IN REPLY REFER TO:
 3482, SL-062583, UTU-76195, (UT-923)

Re: Minor Modification to Resource Recovery and Protection Plan (R2P2), 5 Left Pines East Development, SUFCO Mine

Approved Mine Map

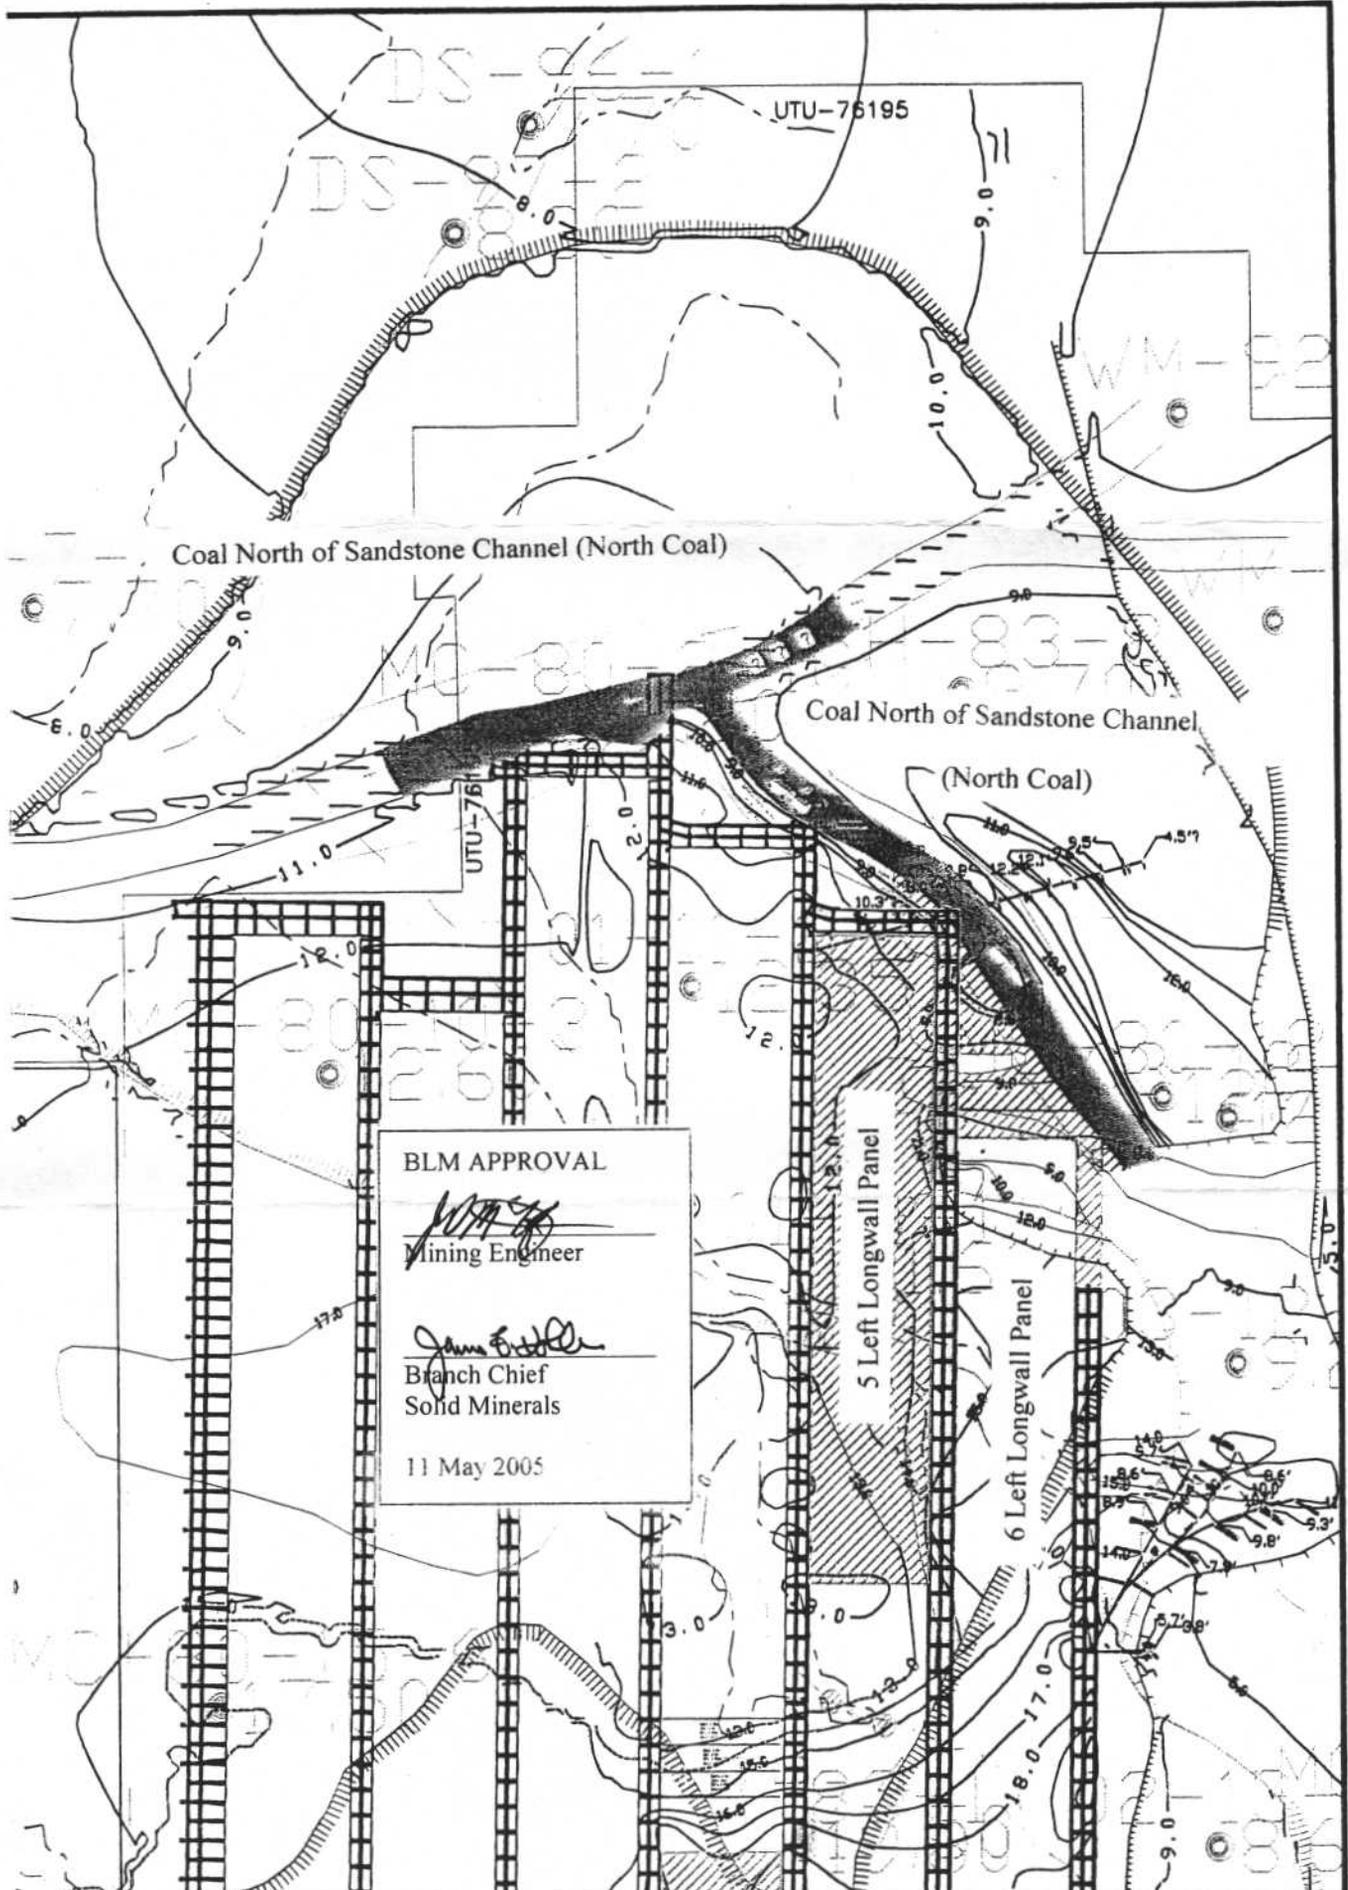
The BLM agrees that the longwall cannot mine through this scour zone without adverse impacts to machinery and unacceptable coal quality as the height limits of the longwall would force cutting 2 feet or more of sandstone rock. Setting up the longwall set up face at crosscut 70, outby the scour zone, is approved (verbal approval was given on 7 January 2005 following the site visit).

As this sandstone channel zone has cut off the north areas of four longwall panels, the BLM recognizes the uncertainties of recovering coal on the north side of this channel (referred to here as the "north coal"). However, recoverable reserve tonnages remain for Federal coal lease UTU-76195. Before mining of the 5 Left longwall panel starts (removing a potential access to the north coal), Canyon Fuel is required to either:

1. submit mining plans and timing for mining of this coal north of the sandstone channel zone, or
2. demonstrate in writing how the north coal reserves will not be isolated from potential future mining, or
3. provide sufficient written economic justification for the case file record for non-recovery of these coal reserves.

The BLM has determined that the proposed modification complies with the Mineral Leasing Act of 1920, as amended, the regulations at 43 CFR 3480, the lease terms and conditions, and will achieve maximum economic recovery of the Federal coal. Canyon Fuel is authorized to halt north development of 5 Left Pines East and mine the longwall set-up face at crosscut 70. However, extraction of panel # 27 (5 Left Headgate) is not approved. This approval confirms verbal approval given earlier. Further justification for the coal reserves to the north and east in the Pines Coal Lease are required as noted above.
